**From:** karl klip FIPPA Sec. 22(1)  
**Sent:** Sunday, March 19, 2023 3:53 PM  
**To:** Bryan, Chris; ayor@burnaby.ca; Keithley, Joe; Santiago, Maita; Planning; LegislativeServices  
**Subject:** Buchanan West Conceptual Master Plan comments  
**Attachments:** 4388 Buchanan concerns presentation.pdf

# 4388 Buchanan St Owner Concerns

## About Buchanan West Conceptual Master Plan

FIGURE 6.14.1

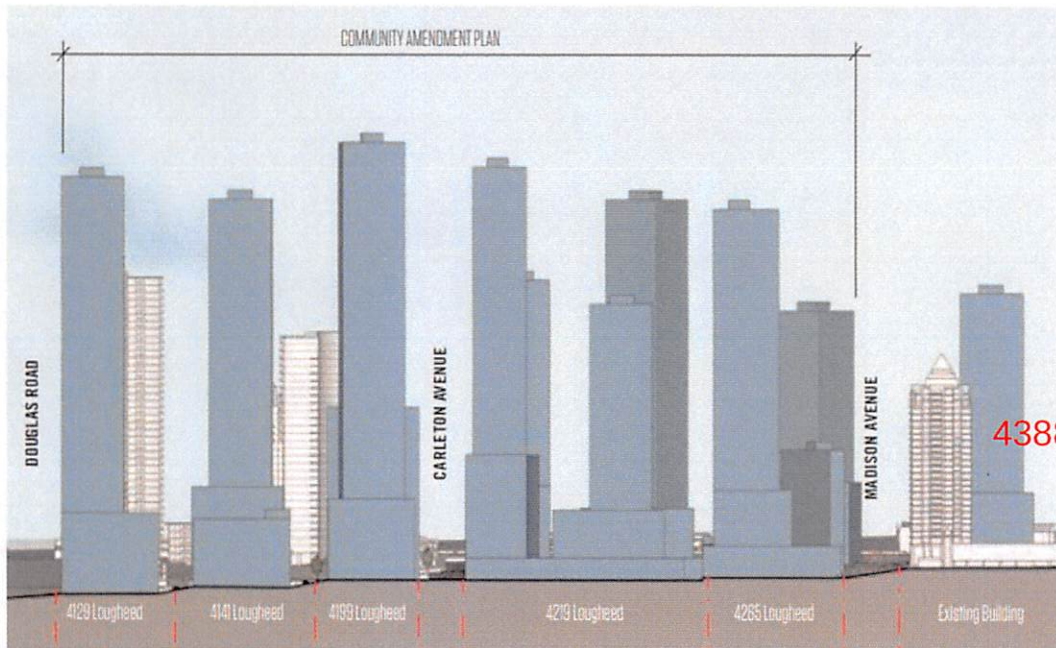
4388 Buchanan St

## 6.5 SITE PLAN

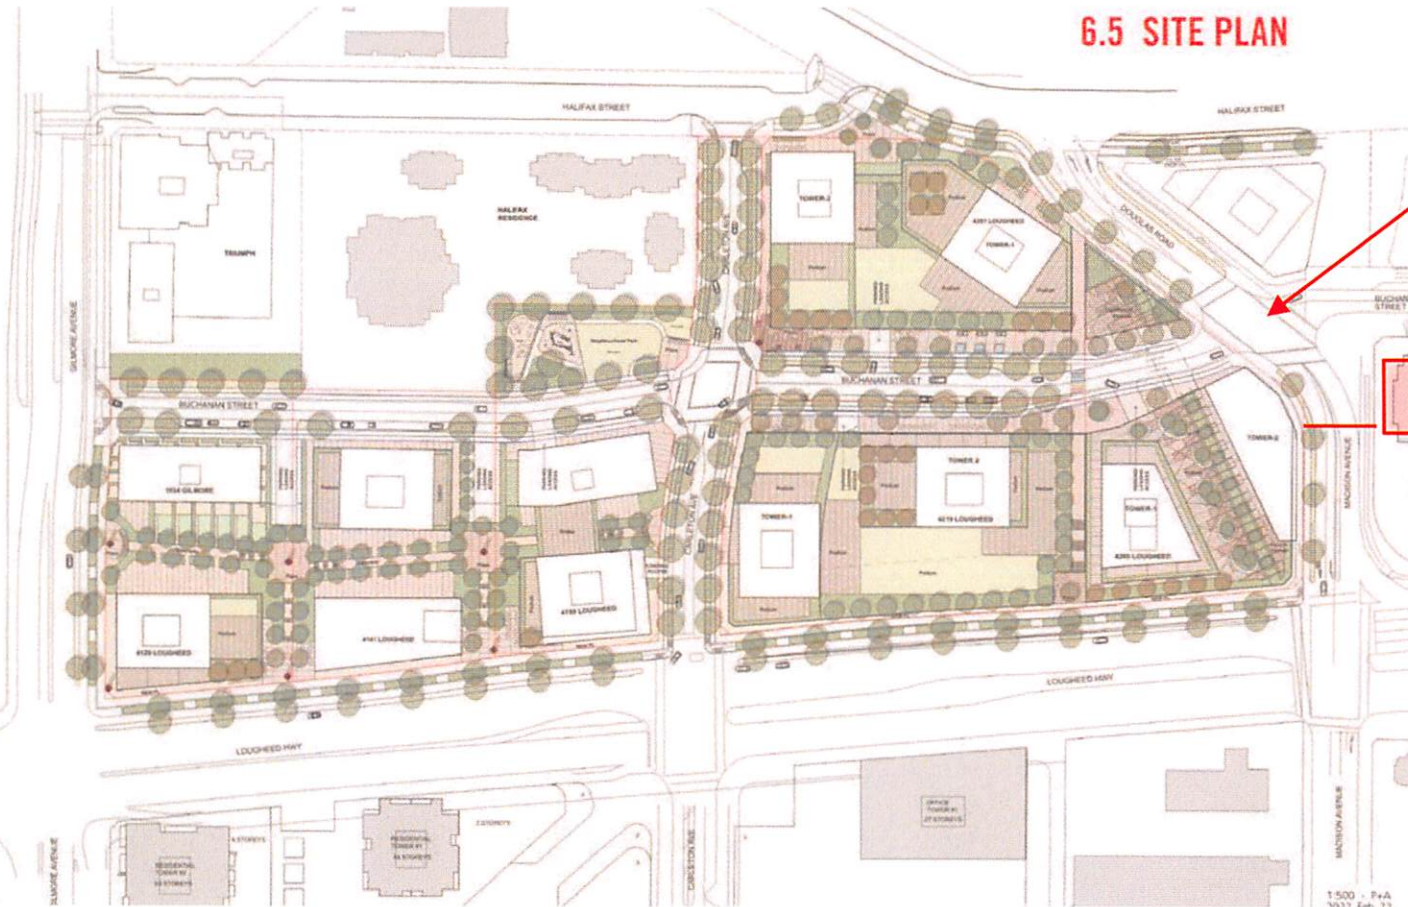
This new road intersection has oddly angled traffic intersection. No traffic lights?

Close proximity between 4388 Buchanan and new building across the street. Issues with shadows and privacy.

## 5.4 URBAN DESIGN GUIDELINES

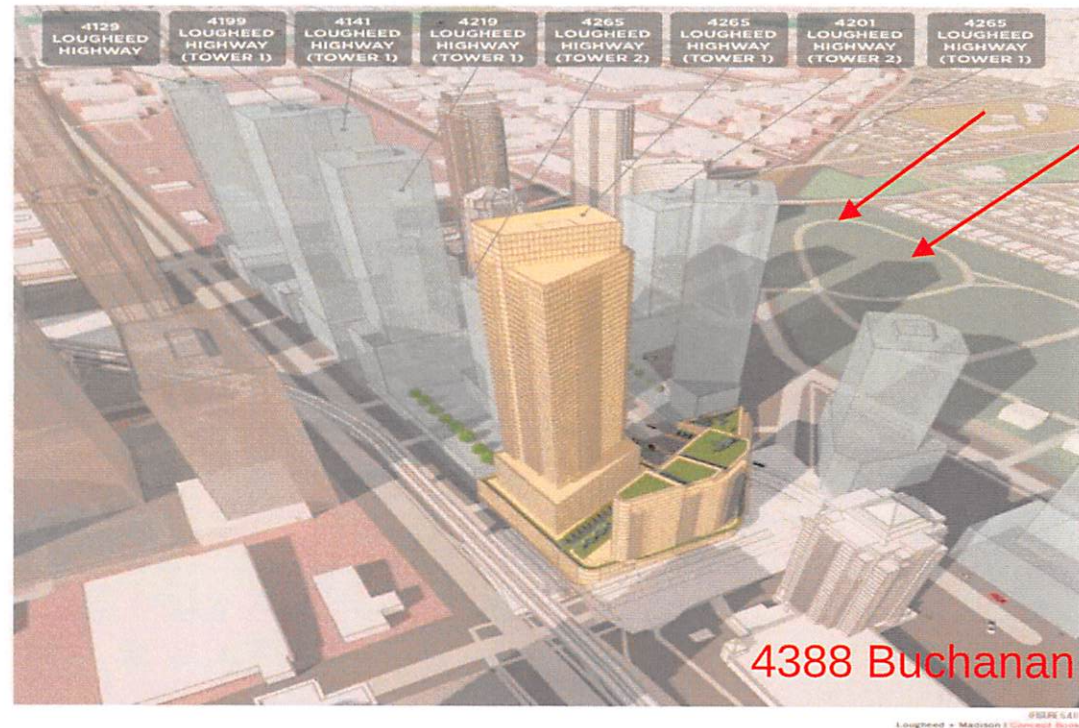
Shadows of new buildings longer than height of 4388 Buchanan.

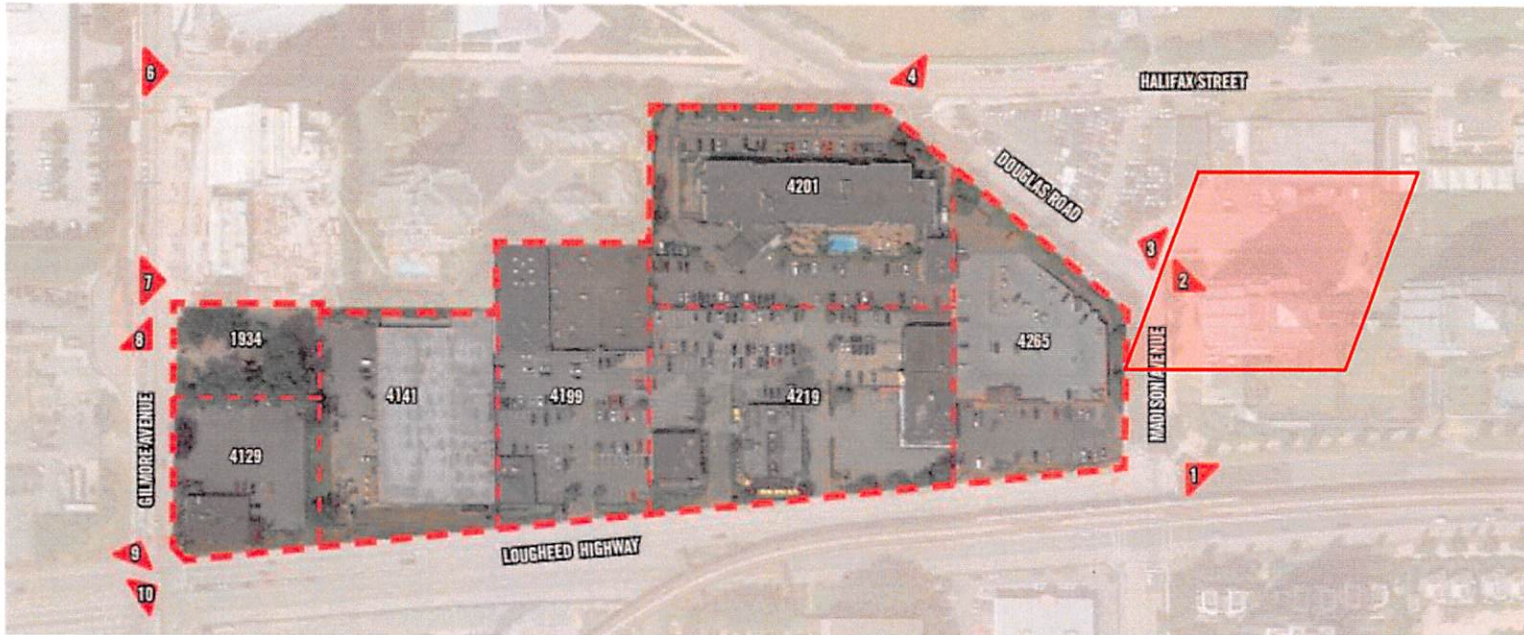
Does not show when shadows will hit 4388 Buchanan and how long the shadows will be. They need to do a 365 day shadow analysis. Can be done using ArcGIS, City of Burnaby GIS.

Only shows 10am and 2pm shadow. Need to show shadowing after 2pm.

Note shadow length at 4388 Buchanan at approx 1pm. Tower is 26 floors.

New towers on lot 4265 along Madison facing 4388 Buchanan will be 40+ stories so shadows will be more than 2x in length.

Exhibit 2.1  
Current Peak Hour Volumes (Balanced 2018)

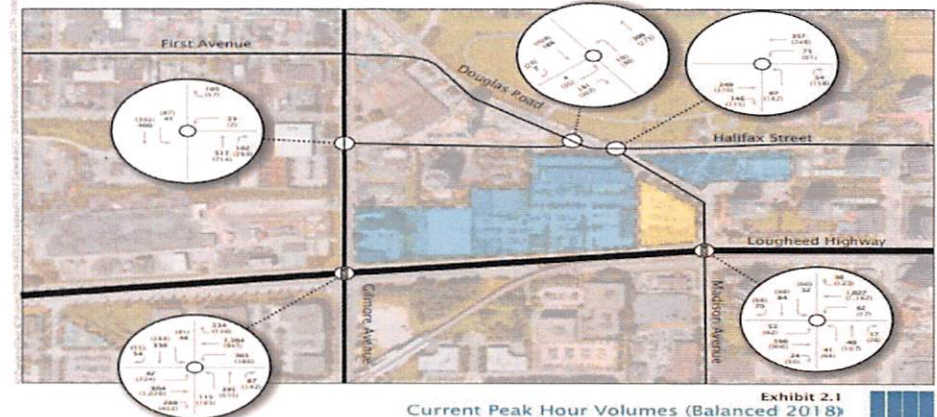
Traffic flow along Madison north to Halifax/Douglas street is a guess from data up to 2018 before the 3-way stop signs were removed to have Halifax/Douglas street as a thoroughfare. Morning and evening rush hour traffic on Madison backs up to Lougheed Hwy.

Exhibit 2.1  
Current Peak Hour Volumes (Balanced 2018)

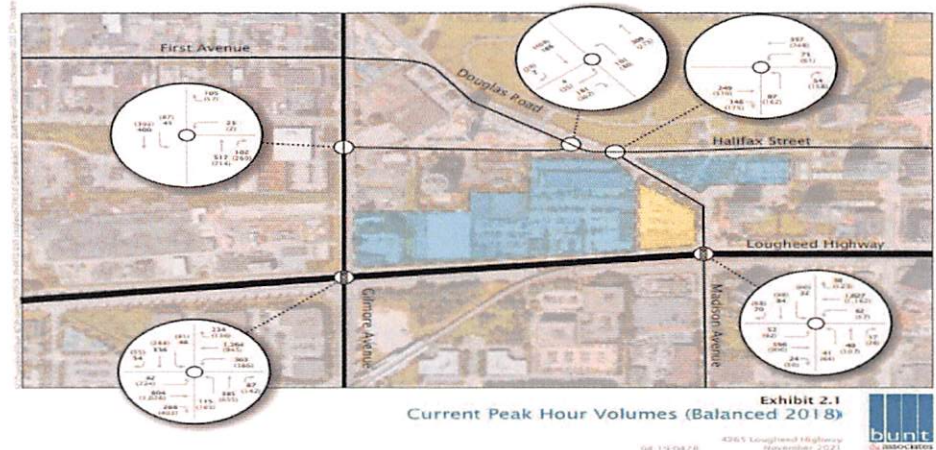
Morning and evening rush hour traffic on Madison backs up to Loughheed Hwy. Plus the evening rush hour (starts 3pm) going east on Halifax to Willingdon has traffic backup to the Madison intersection.

## 6.5 SITE PLAN

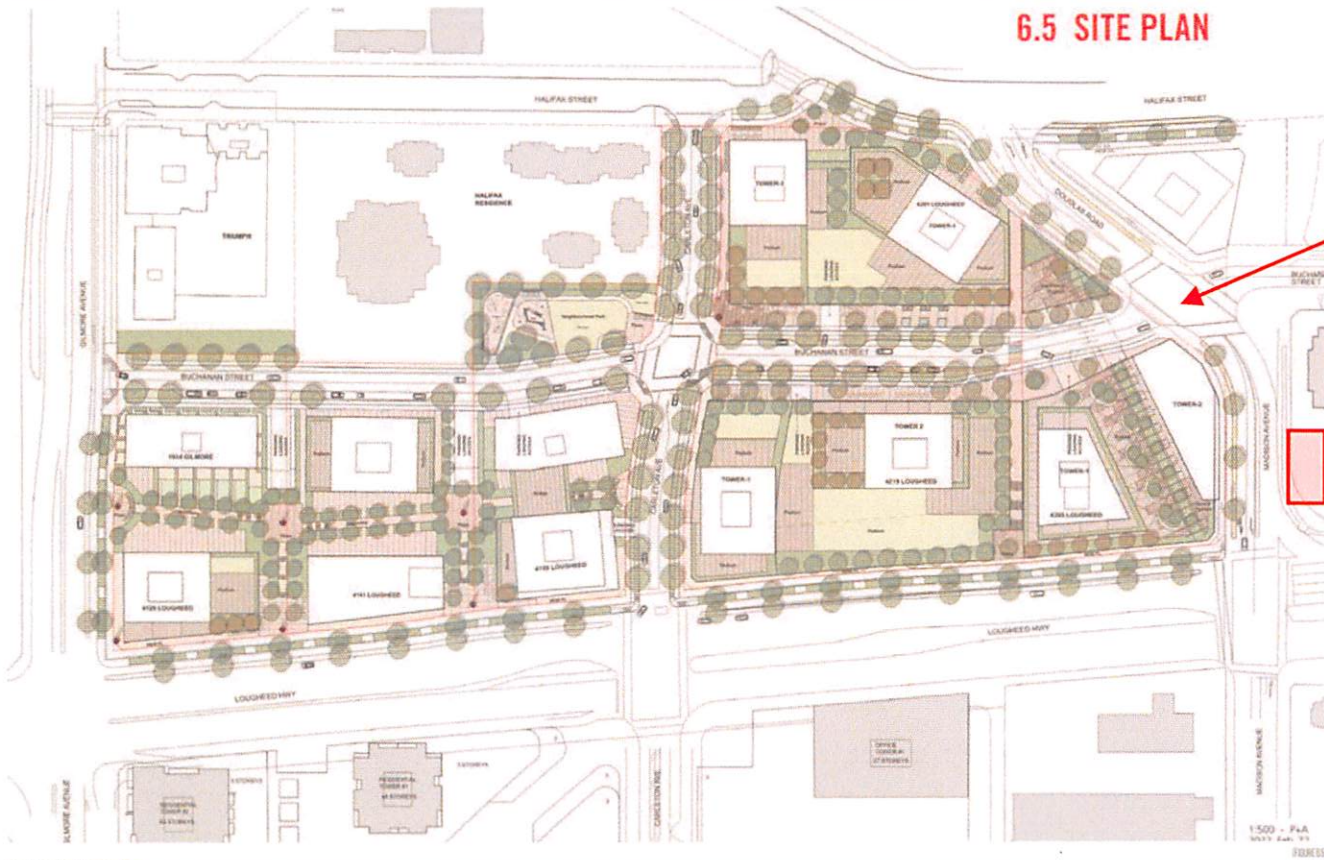
Additional traffic flow onto Madison would be caused by Buchanan St extension from Gilmore. No traffic lights?

Save On Foods trucks need to block Madison to back into ramp for unloading.

Garbage and delivery trucks also use the same ramp.
